# Access Compliance Report

## Public Rights-of-Way

Intersection ID: 27418	Main Street: BALLANTYNE COMMONS PY	Cross Street: BALLANTYNE TRACE CT	Location: NW
ADA ID: BDBA16ACBED4	Ramp Type: Perp	Initial Pass/Fail: Fail	Overall Compliance: No
Severity Score: 12.5			
Codes/Mitigation Info/Possible Solution		Field Measurements/Component Compliance

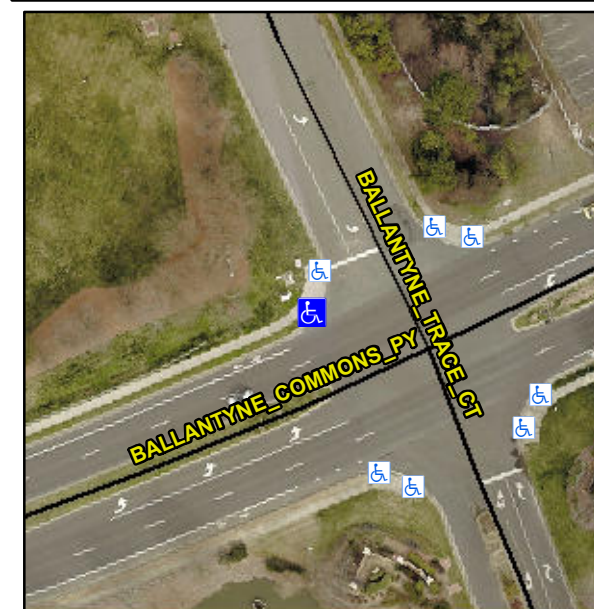
**Not Found, R304.2.2**

Compliance	Description	Data	Compliance	Description	Data
N/A	Ramp Length (in)	108.0	No	Ramp Slope (%)	8.4
Yes	Ramp Width (in)	48.0	Yes	Ramp XSlope (%)	2.0
N/A	Flare Type LT	N/A	N/A	Flare Type RT	N/A
N/A	Flare Slope LT (%)	N/A	N/A	Flare Slope RT (%)	N/A
N/A	Flare Traversable LT?	N/A	N/A	Flare Traversable RT?	N/A
N/A	Landing Length (in)	N/A	N/A	DWS Provided?	N/A
N/A	Landing Width (in)	N/A	N/A	DWS Contrast?	N/A
N/A	Landing Slope (%)	N/A	N/A	DWS Length (in)	N/A
N/A	Landing X Slope (%)	N/A	N/A	DWS Full Width?	N/A
N/A	Landing Curb? (Y/N)	N/A	N/A	DWS Offset (in)	N/A
N/A	Shared Landing?	N/A			
N/A	Gutter Ponding?	N/A	N/A	Gutter Slope (%)	N/A
N/A	Gutter Lip Ht (in)	N/A	N/A	Gutter X Slope (%)	N/A
N/A	Painted X Walk1?	No	N/A	Painted X Walk2?	N/A
	X Walk 1 Direction	To S		X Walk 2 Direction	N/A
N/A	X Walk 1 Width (in)	N/A	N/A	X Walk 2 Width (in)	N/A
	X Walk 1 Slope (%)	8.9		X Walk 2 Slope (%)	N/A
	X Walk 1 X Slope (%)	4.0		X Walk 2 X Slope (%)	N/A

**Remove & Replace Entire Ramp.**
